MINISTRY OF TRANSPORTATION AND COMMUNICATIONS ONTARIO			
BAR RIVER BRIDGE 8.4 MI. WEST OF HWY 348			
KING'S HIGHWAY No. 17		DIST. No. 18	
CO. DIST. ALGOMA		SECTION G	
TWP. LAIRD		CON.	
GENERAL LAYOUT			
APPROVED _____ STRUCTURAL ENGINEER		CONTRACT No. _____	
DESIGN J.F.M. CHECK P.O.L.		W.P. No. 903-72-06	
DRAWING J.F.M. CHECK A.V.		SITE No. 385-145 SHEET 1	
DATE MAR. 75		LOADING 4520-44

BAR RIVER BRIDGE  
W.P. 903-72-06, Site 38S-145  
Hwy. 17, Dist. 18

BAR RIVER BRIDGE

W.P. 903-72-06, Site 38S-145  
Highway 17, District 18

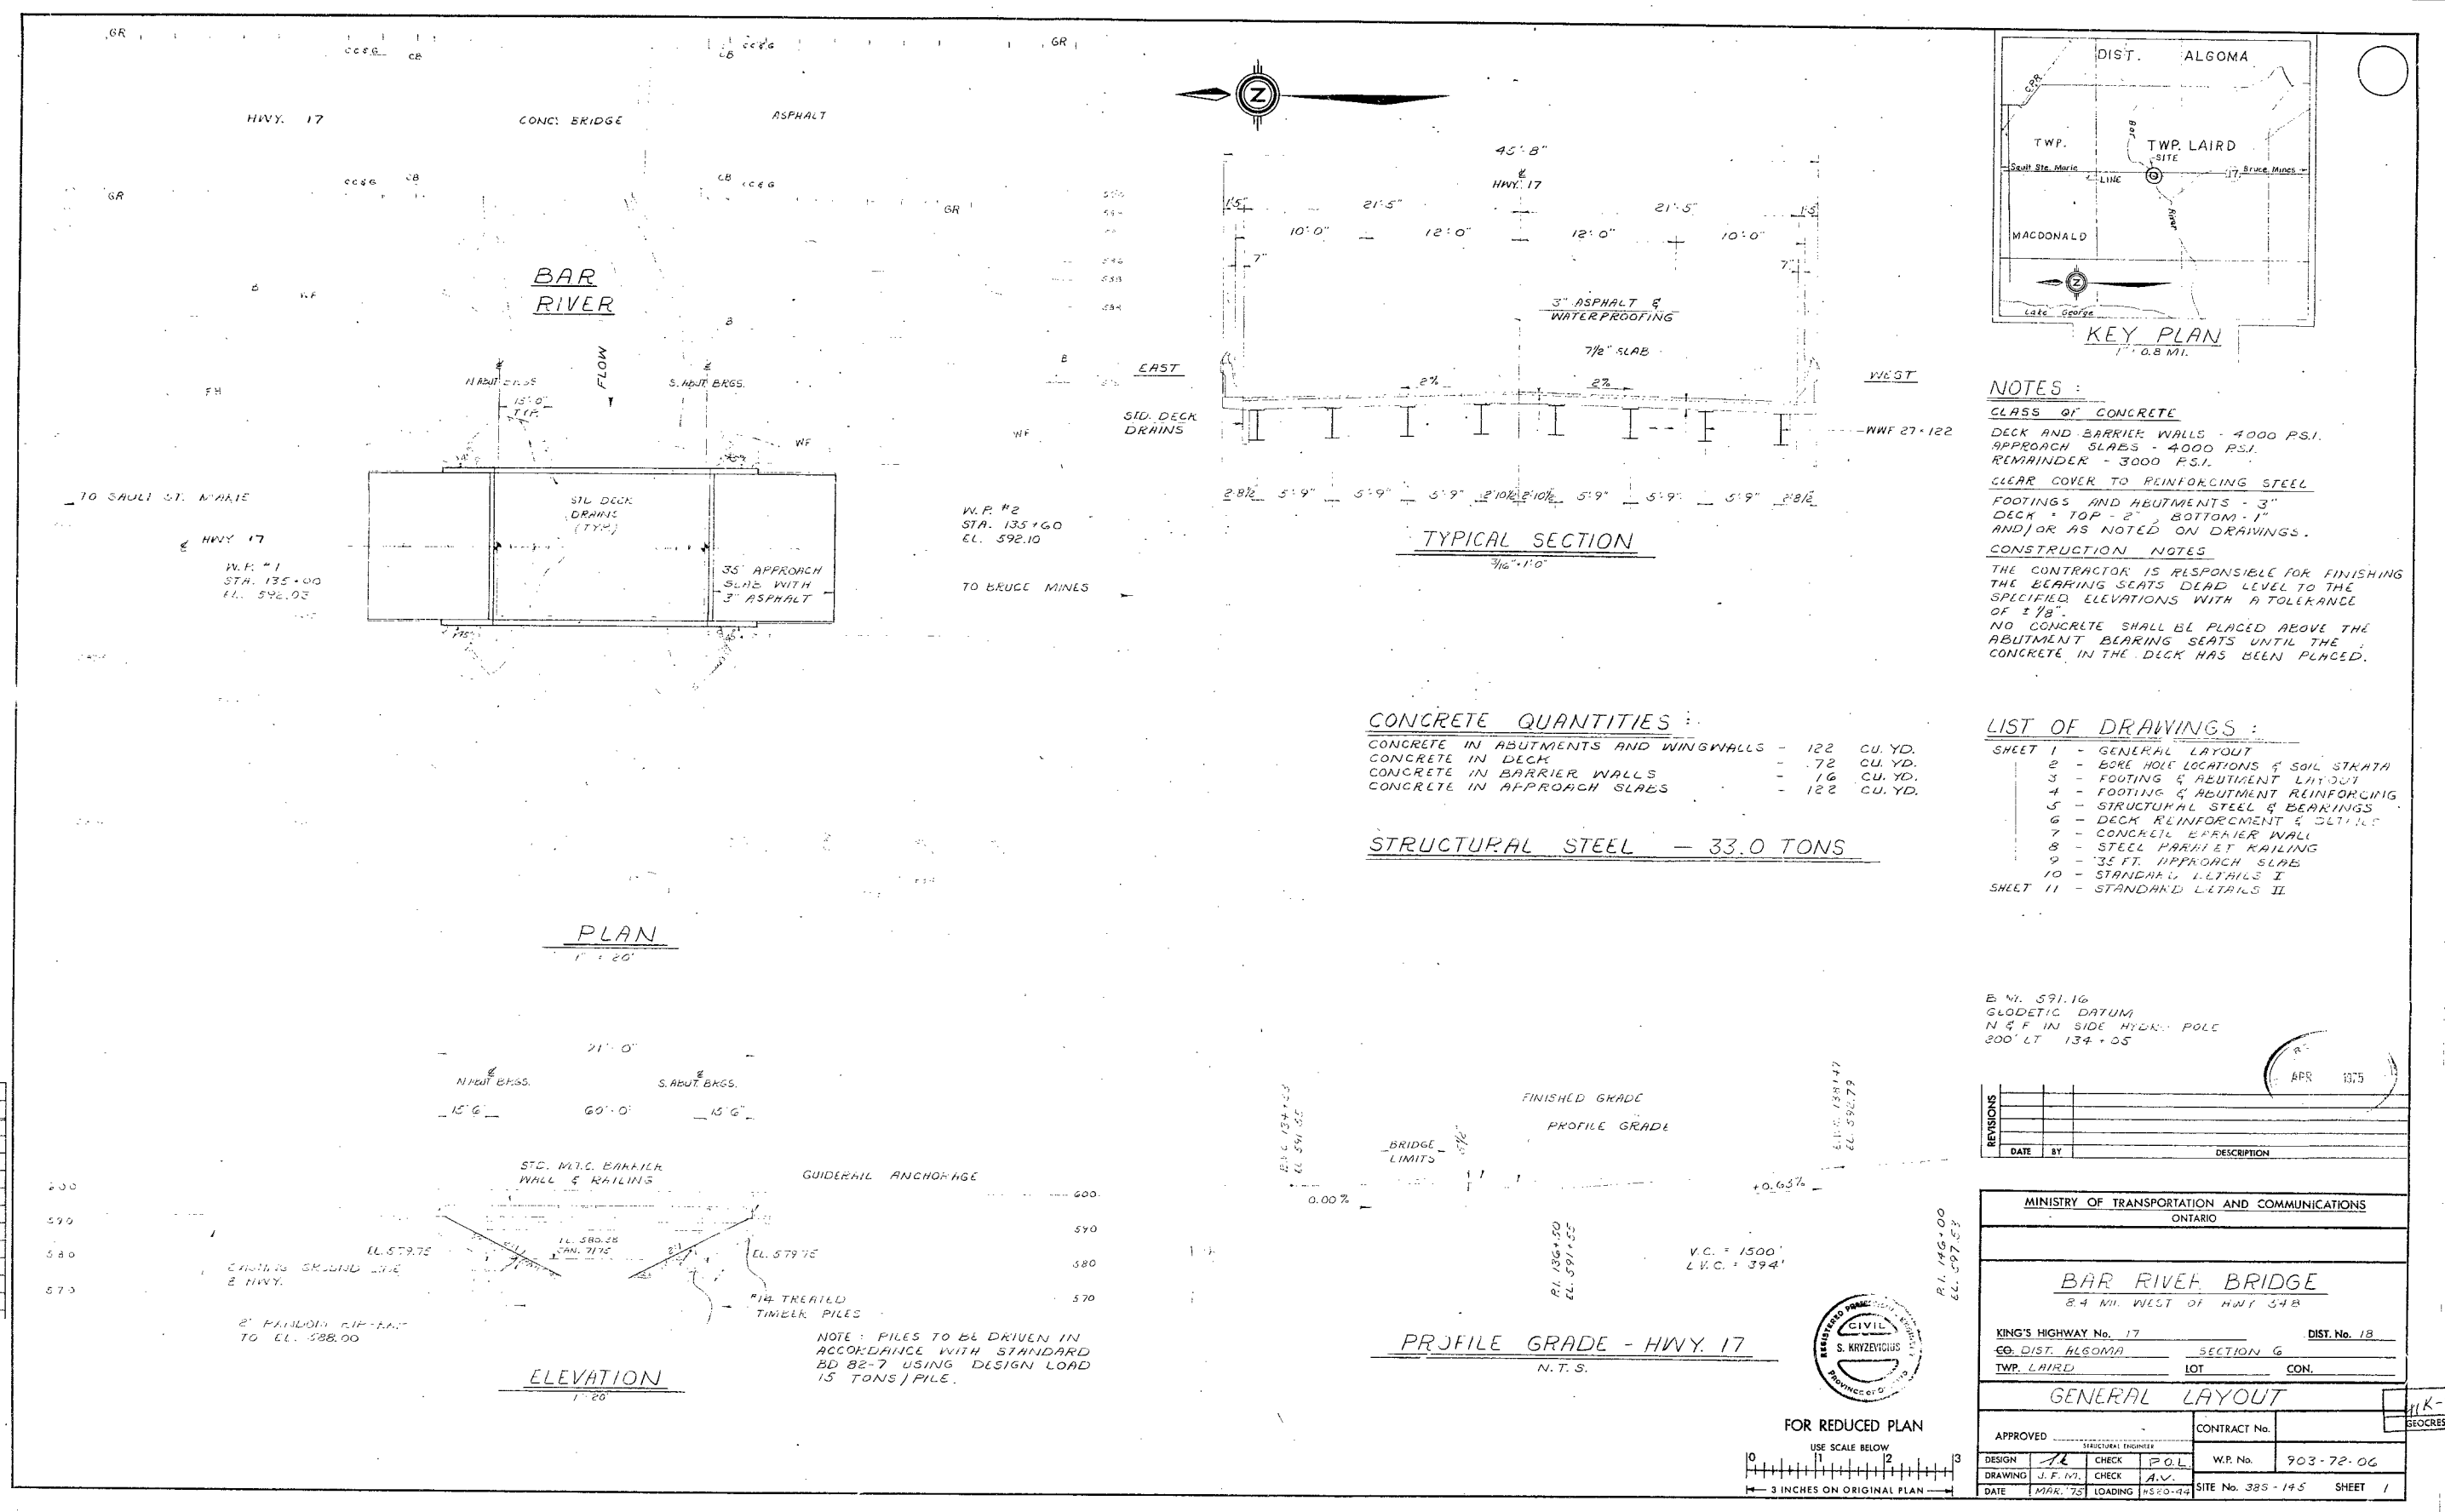
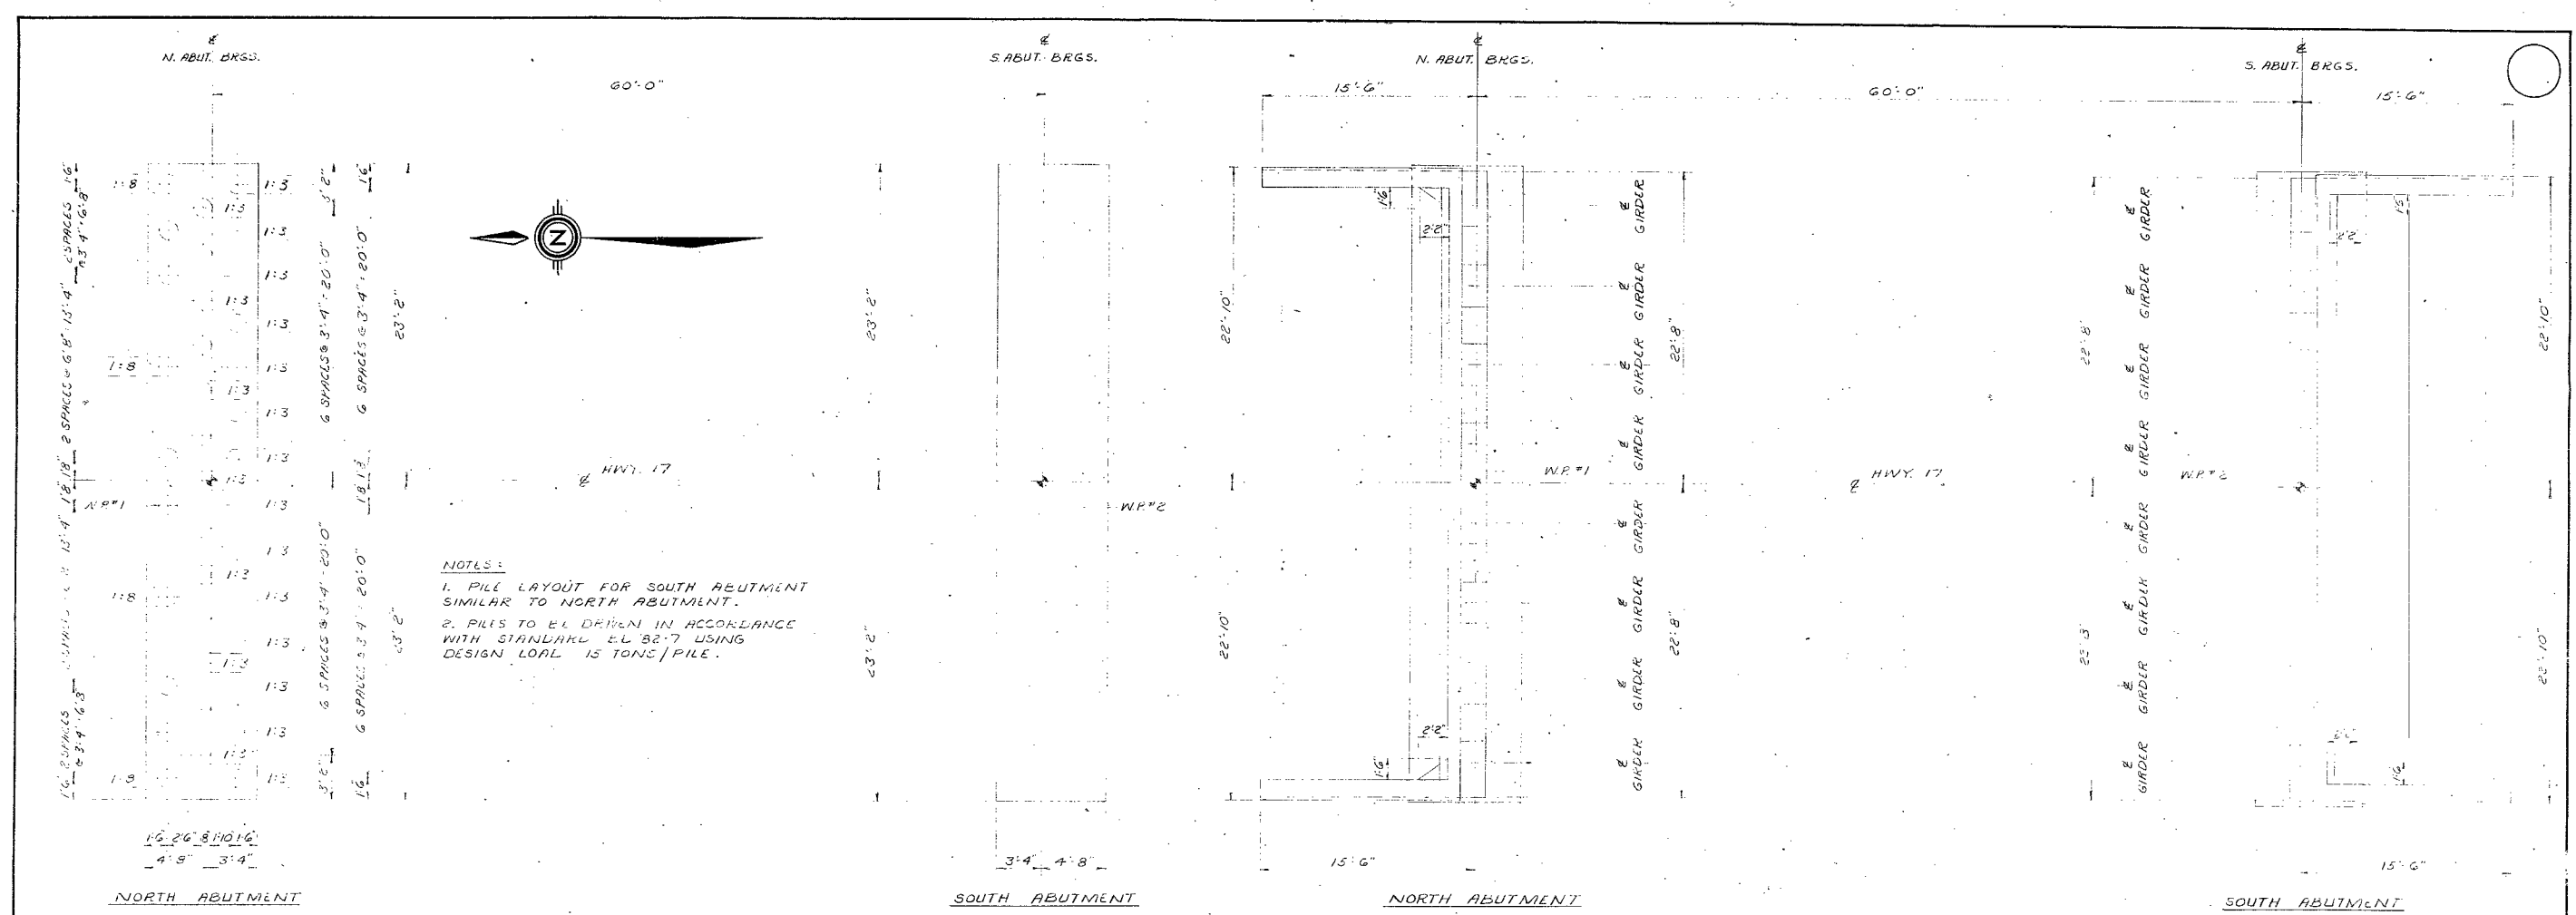
The final bridge drawing shows the profile grade to be 592.1. The proposed 2:1 slopes will be stable in the longitudinal and transverse directions for both granular type of fill material ( $\gamma = 130$  pcf), and for light weight fill ( $\gamma = 90$  pcf - Slag which is locally available from Algoma Steel). The slag material would be better than the granular fill, since the stresses induced by the embankment loading would be lesser, and thus resulting in lesser settlements for the approaches.

**FOOTING & ABUTMENT LAYOUT**

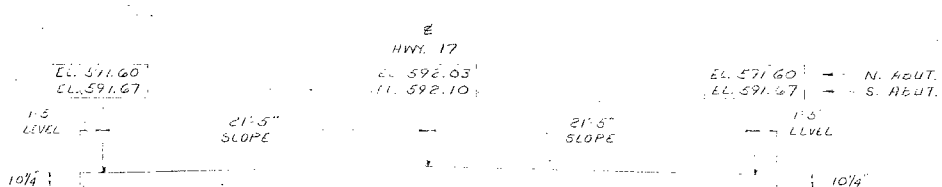
#14 treated timber piles driven to a tip elevation of 525 (approx. 55 ft. long) can be designed for a safe load of 15 tons/pile. Since these piles are friction piles driven into the cohesive clay stratum, pile driving during construction need not be controlled by the Standard BD 82-7, but should be driven to the above-mentioned tip elevation.

The pile driving during construction should not be controlled by means of the Hiley Formula, and should be driven to the predetermined tip elevation (elev. 525), since these are friction piles driven into the clayey subsoil.

Due to the settlement of the proposed roadway embankments, some negative skin friction forces can be imposed on the timber piles supporting the abutments. These forces tend to displace the piles and can cause rotation of the abutments. Therefore, consideration should be given to supporting the extreme ends of the wing walls on timber piles, similar to the abutment piles.

Since the pile caps will be located below the river water level, a temporary earth dyke should be constructed to prevent any water entering the excavation areas from the Bar River. Any minor inflow can be removed by using conventional means, such as pumping from sumps.
